Airport *Link*

Request for Project Change

MAY 2008

Queensland
Government

Figure 3-2
Southern Connection Changed Project

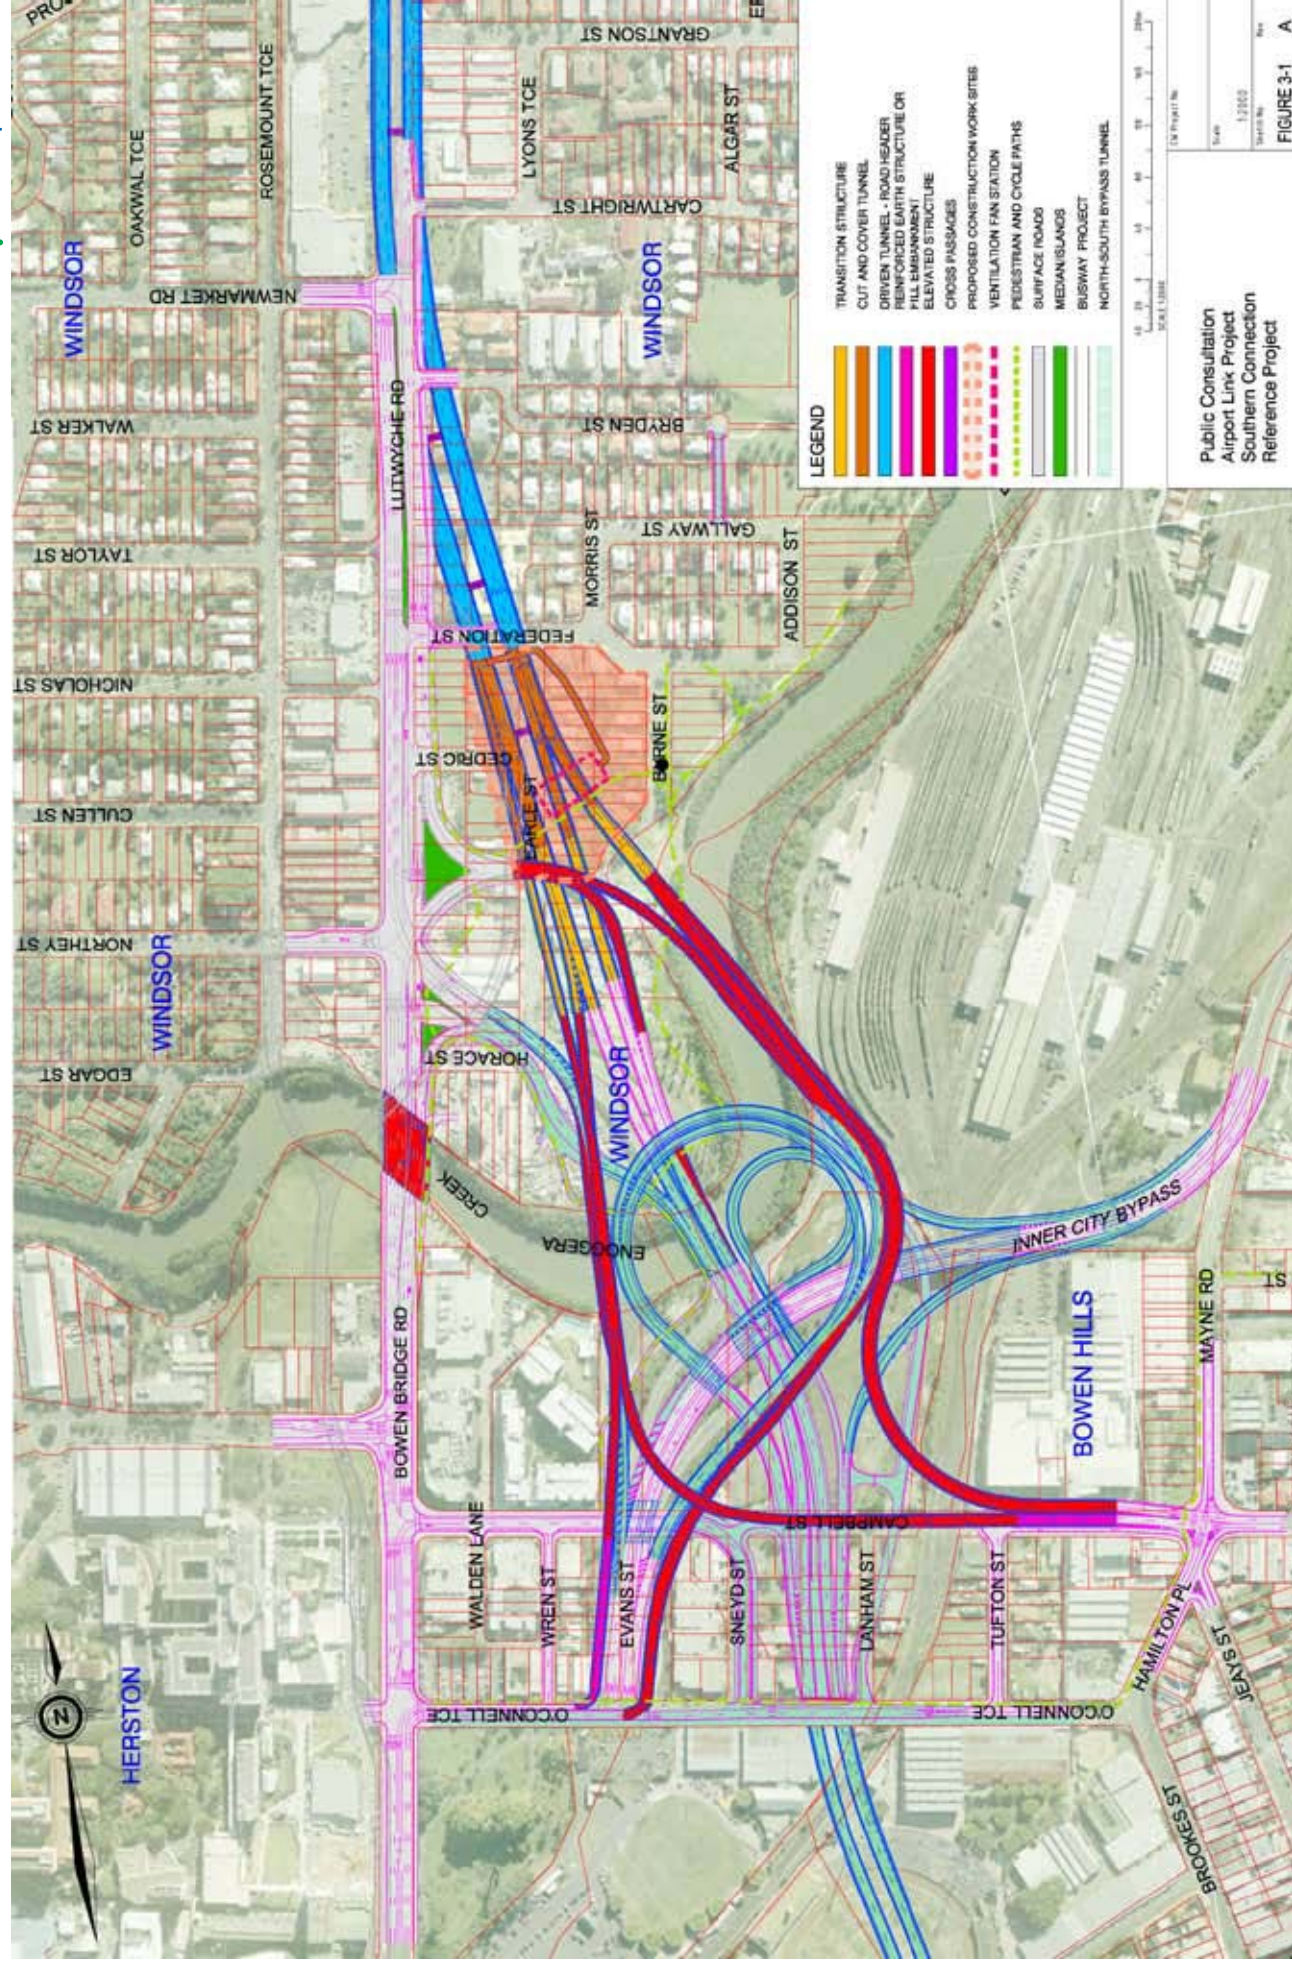
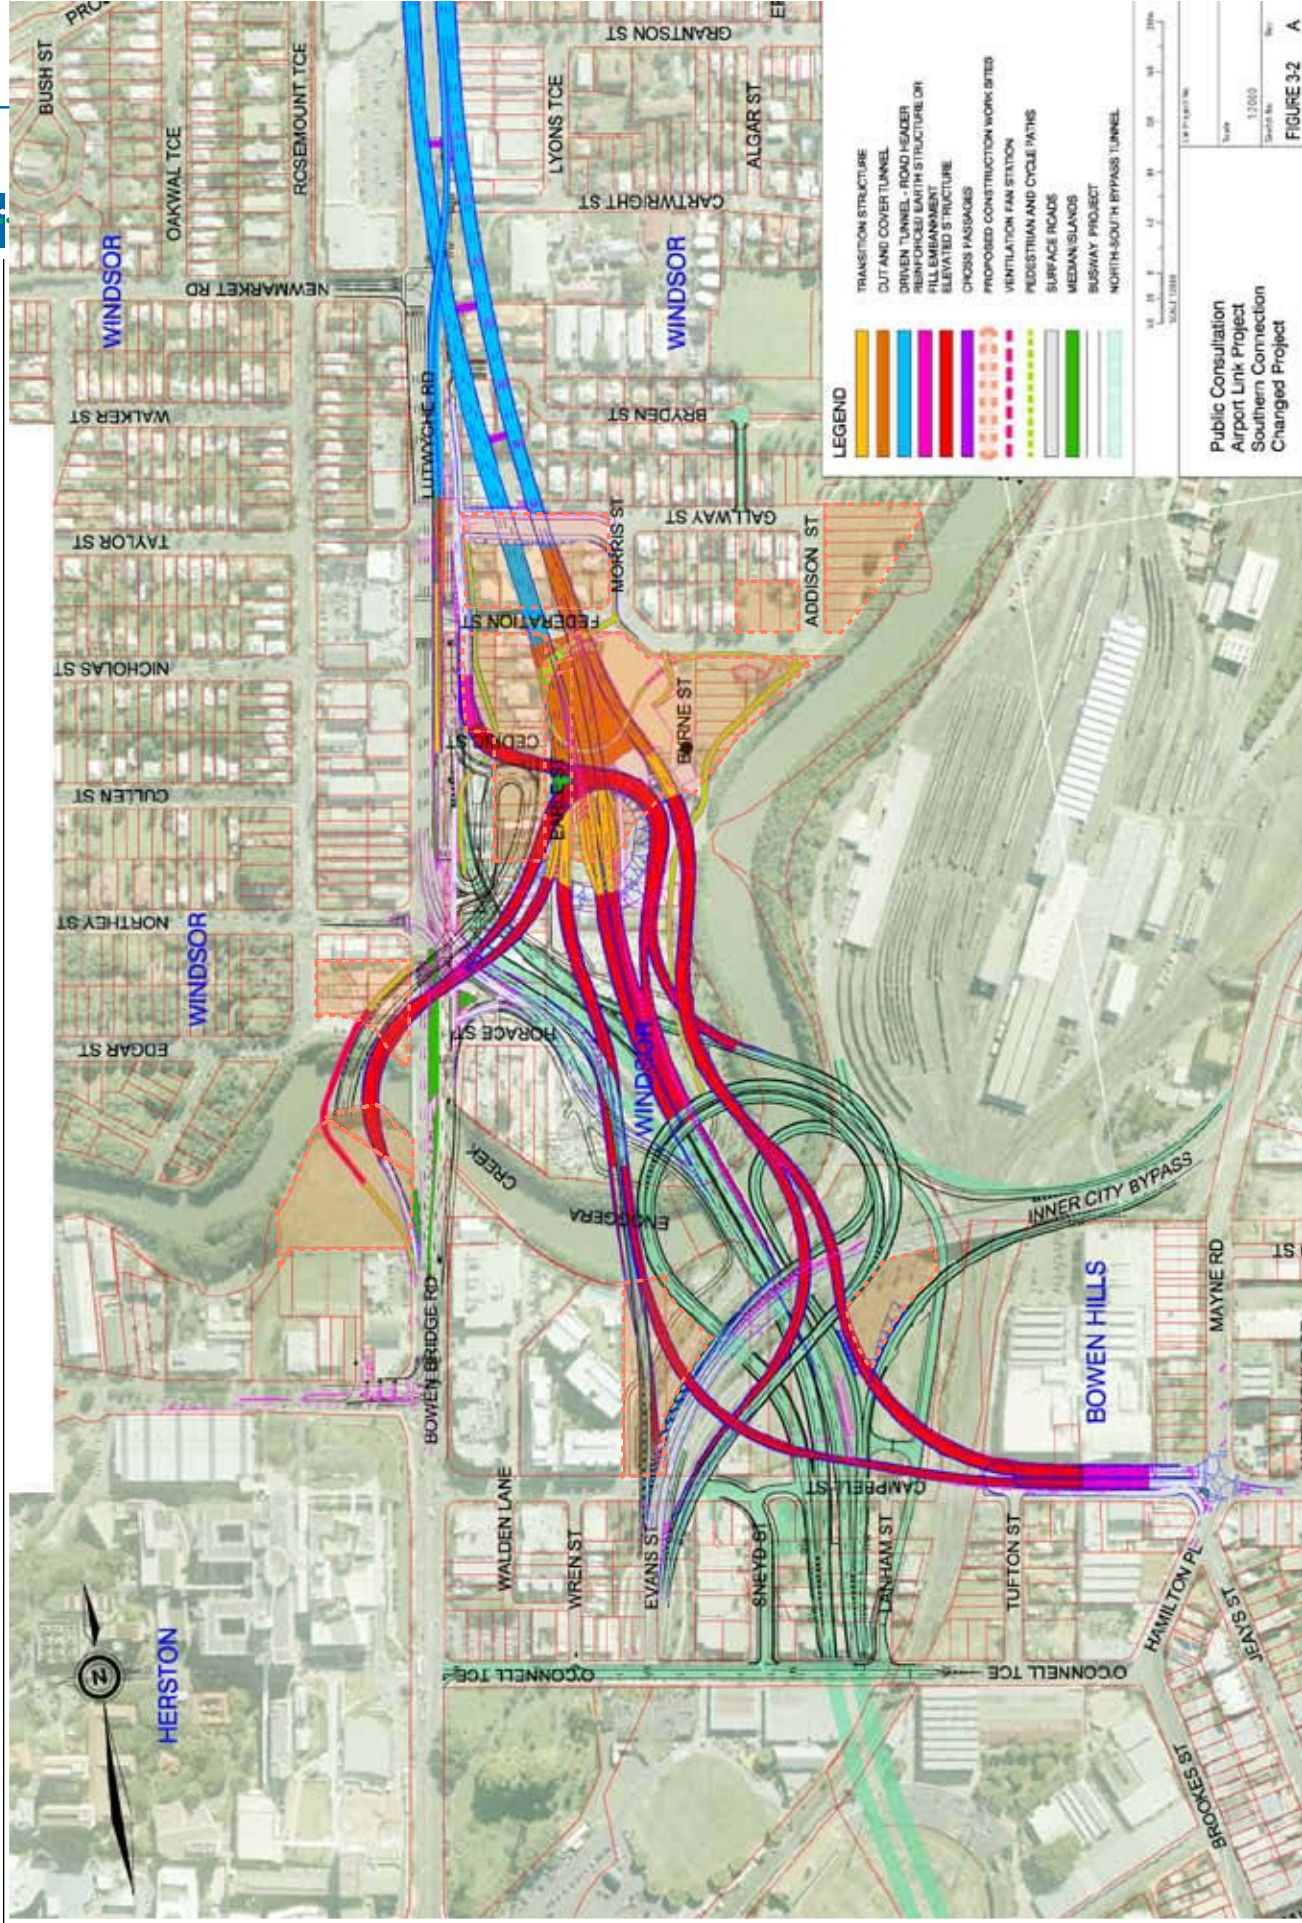
- physical changes to the surface road connections and interchange alignments at Bowen Hills and Windsor to improve their efficiency, reduce impacts on The Mews apartments compared to the Reference Project, provide for better use of existing infrastructure and mitigate impacts on the riparian corridor of Enoggera Creek and the Queensland Rail infrastructure, as follows:

- realignment of the northbound Campbell Street elevated ramp to the north to provide greater separation from The Mews apartments and to remove the Reference Project requirement for a double stacked crossing of Enoggera Creek with the ICB connection;

- realignment of the southbound Campbell Street and ICB connection to pass over the circular NSBT elevated connections, immediately downstream of the NSBT bridge across Enoggera Creek. The proposed bridge alignment would replace the downstream crossing of Enoggera Creek near Mann Park and through the Queensland Rail (QR) Mayne Rail Yards proposed in the Reference Project;

A comparison of the Reference Project and Changed Project at Bowen Hills and Windsor is provided in **Figure 3-1** and **Figure 3-2**.
